SEWAGE DISPOSAL SYSTEM

A REPAIR

HOWARD COUNTY HEALTH DEPARTMENT

SUBDIVISION Eagle's Loft LOT 26 ROAD 13123 Williamfield Drive

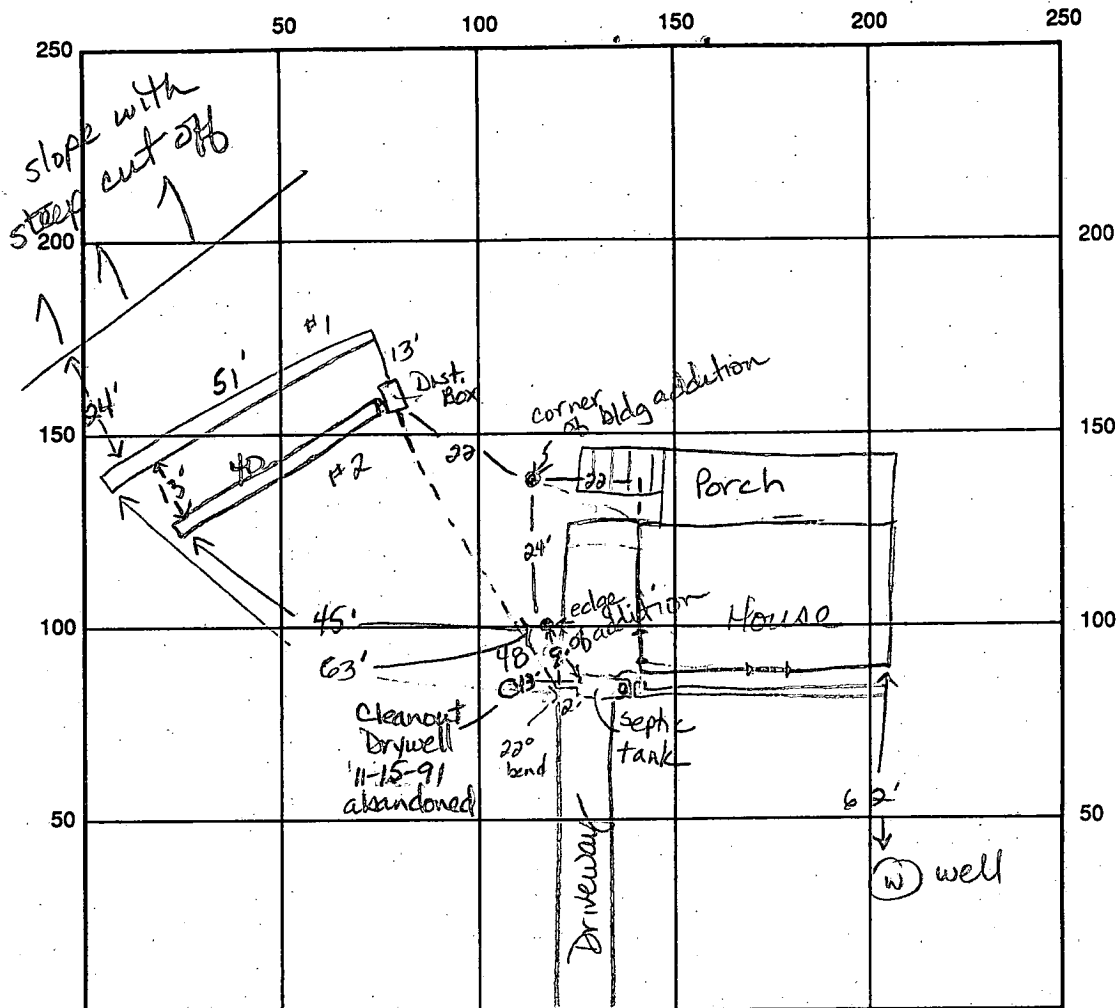
Existing tank location ok per CW letter dated 11-4-91.
12.5 sq ft/blrm = 500 sq ft total, Inlet: 2 ft, bottom: 9.0 ft
7 ft stone. Recommend 80 to 85 ft of trench. JENadeau

REMARKS: 11-14-91 OK to stone and cover trench #1. Line from septic tank to distribution box covered for access to pump drywell. JEN 11-14-91
OK to stone & cover trench #2. OK to collapse drywell.
Pumped 11-15-91 am. JEN

EAGLES LOFT
13123 WILLIAM FRIED
LOT 7

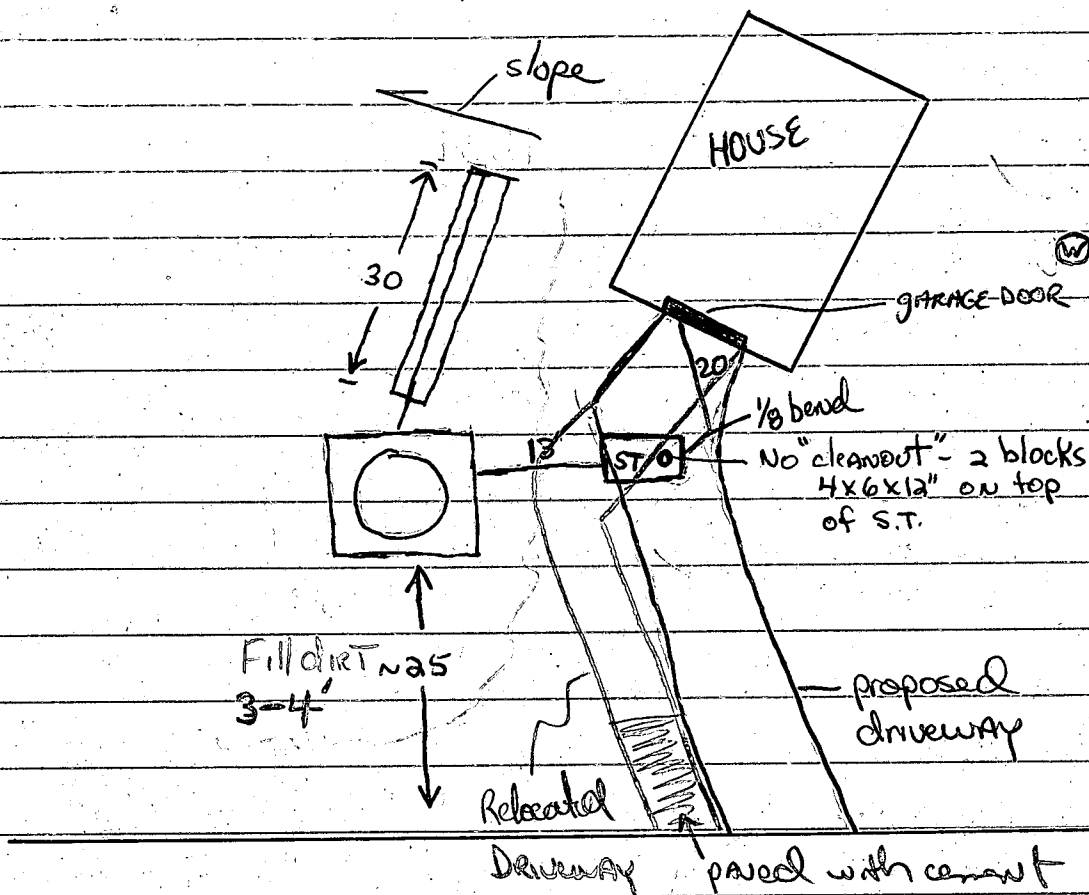
4 Apr. 79 - No cleanouts, 3-4' fill on top of DW/TRENCH, house sewer 3' ~~or~~ septic tank under driveway, house sewer may only have (6" → 1') of cover. (GLK)

4 Apr. 79 - Contacted by Weymouth. Cannot relocate driveway. Suggested he position driveway perpendicular to house sewer and be sure it is properly supported before driveway is paved. Basement is at ground level - trench may be closer than 20'. He will call when cleanouts are installed & trench is broken (GLK)

17 Apr. 79 - Cleanouts installed. ST c/p will not be below driveway. OK to cover. System installed but not approved since sewers are under driveway (GLK)

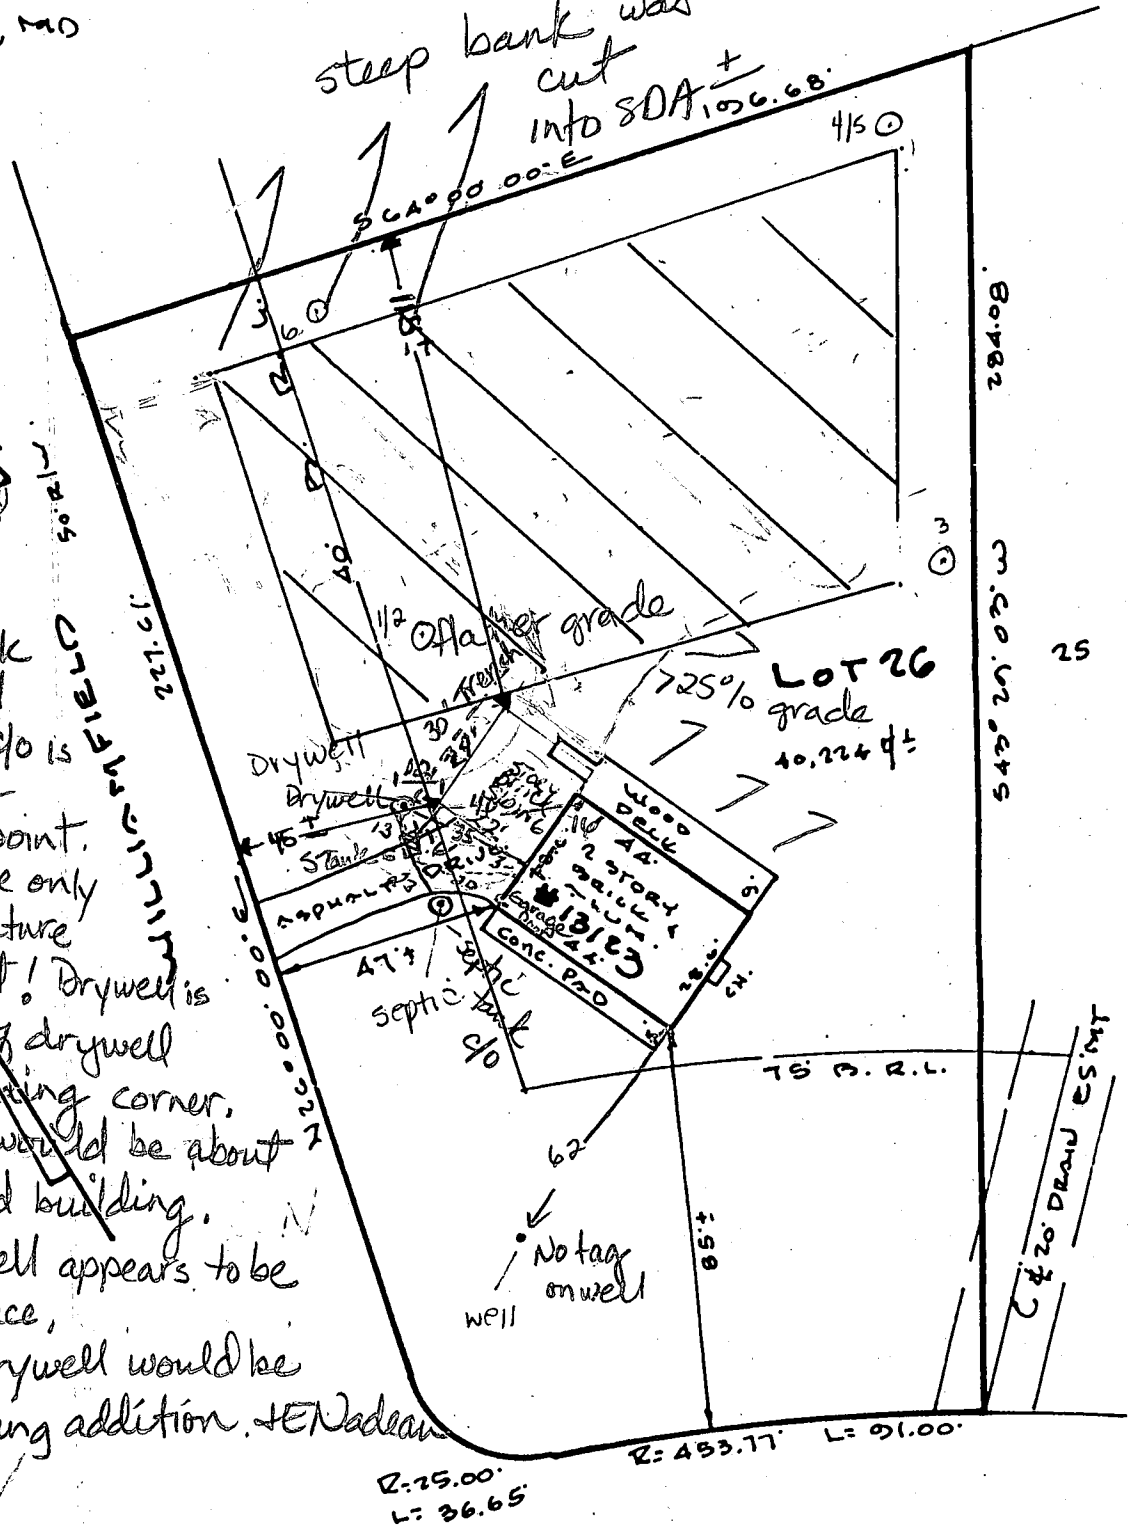
10-4-91 Recommend rejection of proposed addition due to close proximity of drywell, septic tank and sewage disposal easement. Drywell is 35 ft from existing garage at closest point. Addition would leave only 12 feet between structure and drywell cleanout! Drywell is 11x12 ft, so edge of drywell would be at building corner. Septic tank edge would be about 6 feet from proposed building. Liquid level in drywell appears to be 4 to 5 ft below surface. Trench off of drywell would be adjacent to building addition. JEN Wadeau

10-28-91 Met J. Fyock on site to discuss repair placement. Determined that rear of SDA (196.68') was cut prior to septic installation. Therefore total SDA does not exist as shown. Recommend 80 ft to 85 ft of trench (best fit) with 7A stone, a minimum of 42 ft off garage. Tank is 6 ft 4 in to edge of proposed building. Owner may agree to adjust building several feet from tank. Recommend 10 ft minimum separation to building. JEN
